SI B17 01 03  
Cooling Systems

### Coolant Level Warning Light On

X5 with 4.4 and 4.6 liter engine from start of production to 4/20/03

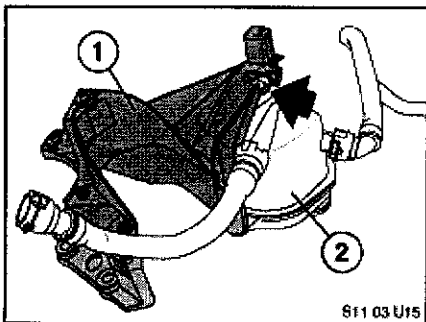
Insufficient clearance between underside of the coolant expansion tank (2) and the support bracket (1) as indicated by the arrow in illustration. Contact between the bracket and the coolant level sensor, located on the underside of the expansion tank, causes damage to the sensor which, in turn, leads to warning light illumination.

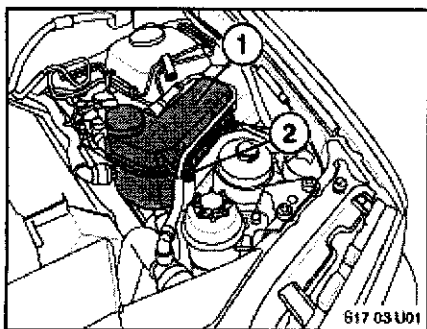
The new part has a cutout in the area of the coolant level sensor which eliminates the area of contact. Note area indicated by arrow.

On a customer complaint basis and where there is evidence of sensor to bracket interference, replace the existing bracket with the new modified support bracket currently available through Parts. The part number remains the same as the original part. Additionally, replace the coolant level sensor.
